UNITED STATES PATENT AND TRADEMARK OFFICE

APPLICATION NO.	FILING DATE	FIRST NAMED INVENTOR	ATTORNEY DOCKET NO.	CONFIRMATION NO.
10/688,136	10/17/2003	John David Mann	27425-0001	2015
7590 11/16/2006			EXAMINER	
Mr. Michael J. Roman c/o Clark, Wilson 800 - 885 West Georgia Street Vancouver, BC V6C 3H1 CANADA			LHYMN, EUGENE	
			ART UNIT	PAPER NUMBER
			3781

Office Action Summary	Application No.		Applicant(s)	
	10/688,136		MANN, JOHN	
	Examiner		Art Unit	
	Eugene Lhymn		3781

DETAILED ACTION

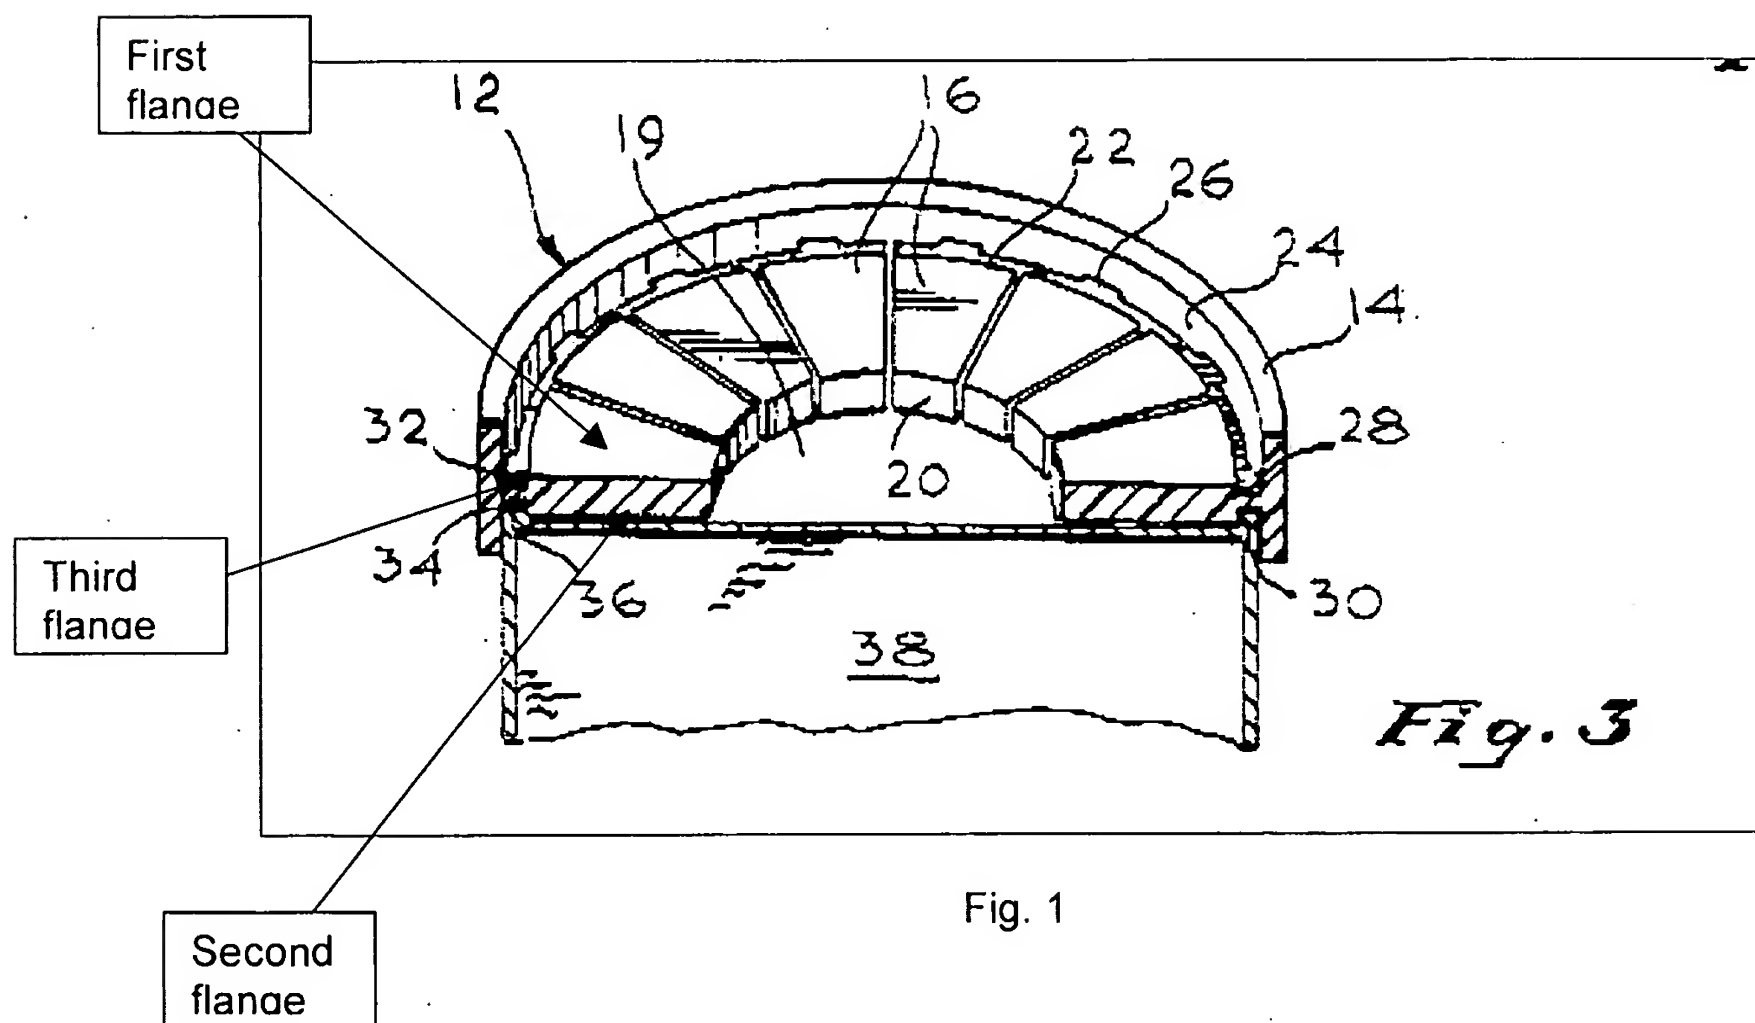
7. Applicant's arguments filed 8/23/06 have been fully considered but they are not persuasive. With respect to claim 1, the upper and lower flanges DO NOT circumscribe the third flange. The upper and lower portions of 16 are radially inward from the third flange which extends perpendicularly beyond therefrom. See Fig. 1 below.
